UNITED STATES PATENT AND TRADEMARK OFFICE

APPLICATION NO.	FILING DATE	FIRST NAMED INVENTOR	ATTORNEY DOCKET NO.	CONFIRMATION NO.
10/626,361	07/23/2003	Jeremy A. Davis	200210054-1	1224

Office Action Summary	Application No. 10/626,361	Applicant(s) DAVIS, JEREMY A.	
	Examiner William H. Rodriguez	Art Unit 3746

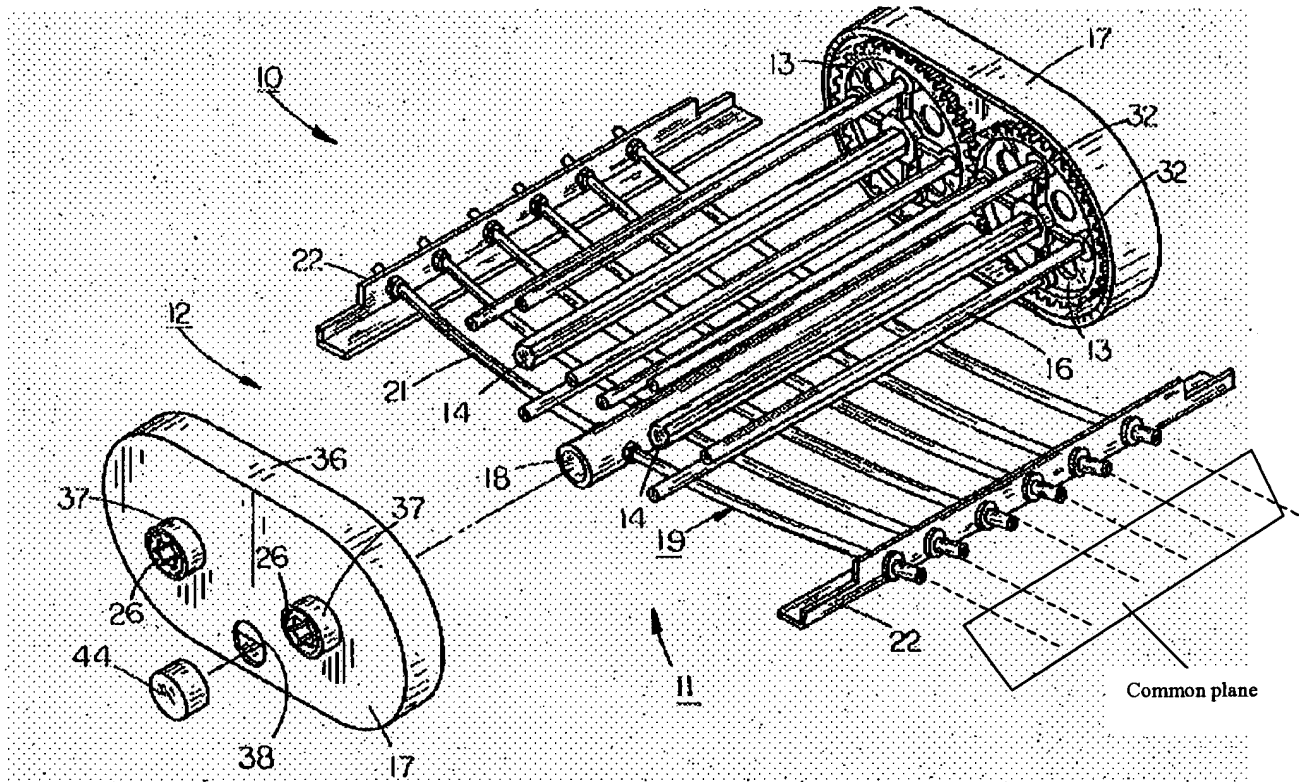
With respect to claim 1, **Schartz** teaches a pump having a rotary portion 16 which compels the movement of a fluid by peristaltic compression of resilient tubing 19 containing the fluid, a tube component comprising a plurality of adjacent resilient tubes; a web 22 interconnecting the adjacent resilient tubes. See particularly Figure above.

With respect to claim 2, **Schartz** teaches that the resilient tubes has a cross-sectional centerline occurring in a common plane, and the web interconnects the resilient tubes in an area outside of the common plane. See particularly Figure above.

With respect to claim 3, **Schartz** teaches that the rotary portion of the pump includes a rotary area of pump operation, and the web is outside the rotary area of pump operation. See particularly Figure above:

With respect to claim 13, **Schartz** teaches a method of assembling a pump having a rotary portion 16 which compels the movement of a fluid by peristaltic compression of resilient tubing 19 containing the fluid comprising the following: providing a plurality of adjacent resilient tubes, and interconnecting the adjacent resilient tubes with a web 22. See particularly Figure above.

With respect to claim 14, **Schartz** teaches that providing a plurality of adjacent resilient tubes comprises providing each of the resilient tubes with a cross-sectional centerline occurring in a common plane, and interconnecting the adjacent resilient tubes with a web comprises interconnecting the resilient tubes in an area outside of the common plane. See particularly Figure above.

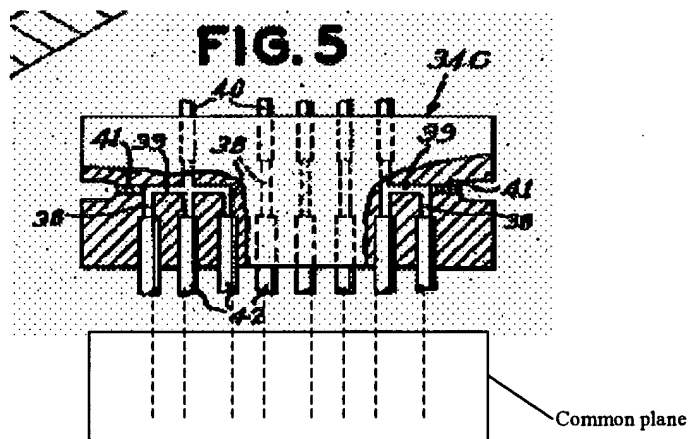
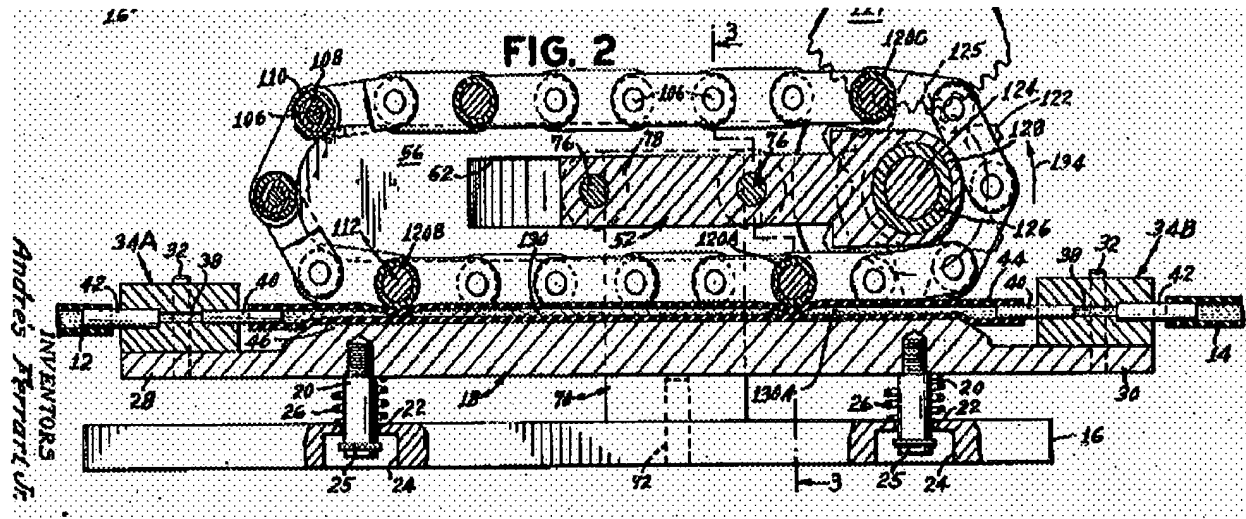
With respect to claim 1, Ferrari teaches a pump having a rotary portion 120 which compels the movement of a fluid by peristaltic compression of resilient tubing (44, 40, 42) containing the fluid, a tube component comprising a plurality of adjacent resilient tubes; a web 34C interconnecting the adjacent resilient tubes. See particularly Figures 2, 5 above and column 4 lines 59-71 of Ferrari.

With respect to claim 2, **Ferrari** teaches that the resilient tubes has a cross-sectional centerline occurring in a common plane, and the web interconnects the resilient tubes in an area outside of the common plane. See particularly **Figure 5** above.

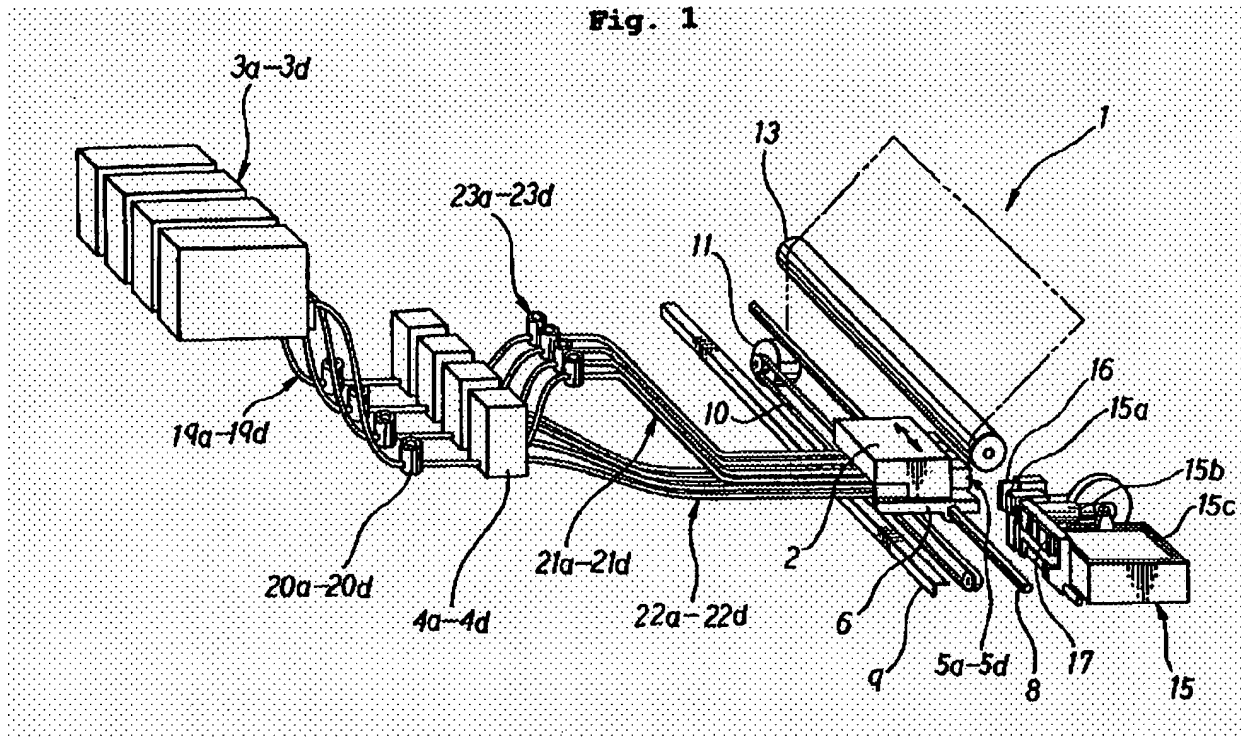
With respect to claim 3, **Ferrari** teaches that the rotary portion of the pump includes a rotary area of pump operation, and the web is outside the rotary area of pump operation. See particularly **Figures 2, 5** above.

With respect to claim 13, **Ferrari** teaches a method of assembling a pump having a rotary portion 120 which compels the movement of a fluid by peristaltic compression of resilient tubing (40, 42, 44) containing the fluid comprising the following: providing a plurality of adjacent resilient tubes, and interconnecting the adjacent resilient tubes with a web 34C. See particularly **Figures 2, 5** above and column 4 lines 59-71 of Ferrari.

With respect to claim 14, **Ferrari** teaches that providing a plurality of adjacent resilient tubes comprises providing each of the resilient tubes with a cross-sectional centerline occurring in a common plane, and interconnecting the adjacent resilient tubes with a web comprises interconnecting the resilient tubes in an area outside of the common plane. See particularly **Figure 5** above.

With respect to claim 15, **Ferrari** teaches that the rotary portion of the pump includes a rotary area of pump operation, and interconnecting the adjacent resilient tubes with a web comprises interconnecting the resilient tubes in an area outside the rotary area of pump operation. See particularly **Figures 2, 5** above.
